Date: February 6, 2022
 To: Planning and Zoning Board
 From: Ellen Hardgrove, City Planning Consultant
 Allen Lane, CPH Engineering, City Engineering Consultant
 Jim Winter, CPH Engineering, City Landscape Architect Consultant
 XC: Sandy Riffle, Interim City Clerk
 Brett Sollazzo, Administrative Assistant
 Drew Smith, City Attorney
 Re: Mecatos Bakery and Café Site Plan/Waiver/Variance Application

This agenda item is for approval consideration of the site plan package for the Mecatos Bakery and Café that was submitted electronically to the City on January 27, 2022. The package includes the following

Approval of the Mecatos Site Plan Package submitted electronically to City Hall January 25, 2022, subject to the following changes made and represented on the revised plans as clouded information, a revision note added to the plans, and as well as a written response to all needed changes listed below to be submitted to City Hall by February 28, 2022 at noon.

MECATOS BAKERY & CAFE

C-100

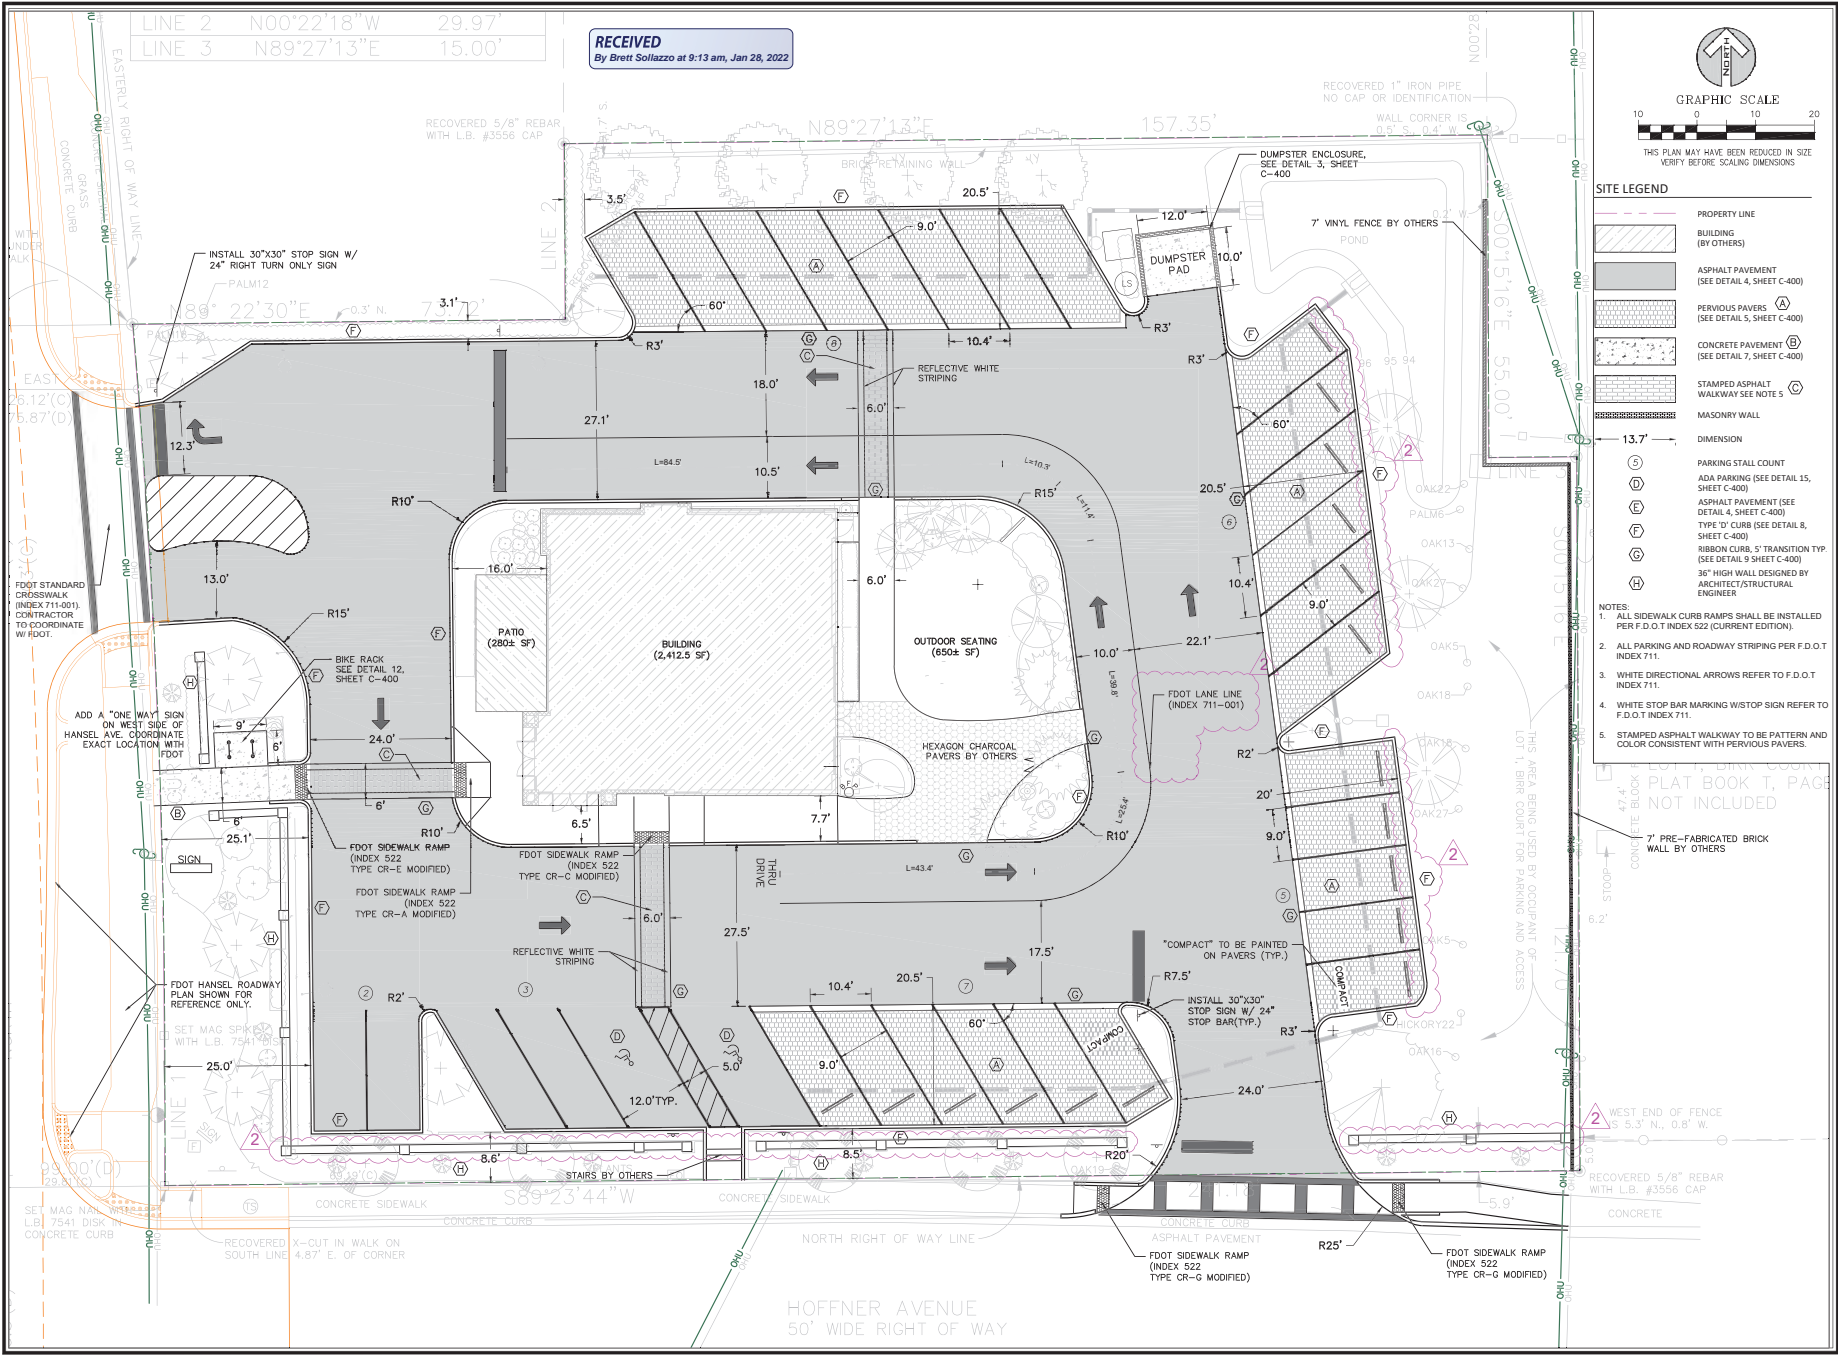
17. Sheet C-001 Standard Sewer and Water Notes – correct numbering under this section, some note numbers are repeated.
 18. Sheet C-100, change the lane line separating the drive-through from the circulating traffic to one single solid white line and add note referencing the lane line width and color.

19. Sheet C-100, add the radius for the curbing on each side of the entrance/exit to Hansel Avenue verifying that the Fire Truck Turning Radius Plan, which is to be a 30-foot radius, is provided.

20. Sheet C-100, add the call out for the Stop Sign and Right Turn Only Sign at the drive lane connection to Hoffner Avenue.
 21. Sheet C-300, eliminate the bend in the proposed gravity sanitary sewer to provide for a straight connection between the grease trap and the lift station.

WEST ELEVATION

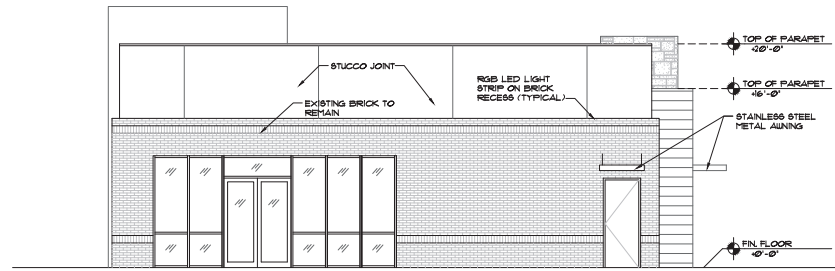
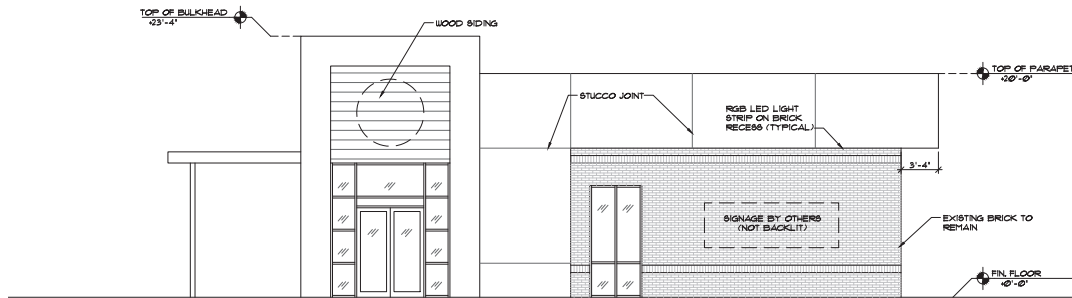
2. Identify who the “others” are that will build the stairs.
3. On the elevation sheet, correct the metal awning arrow (West elevation) and stucco joint (West and South Elevations) which are in wrong place.
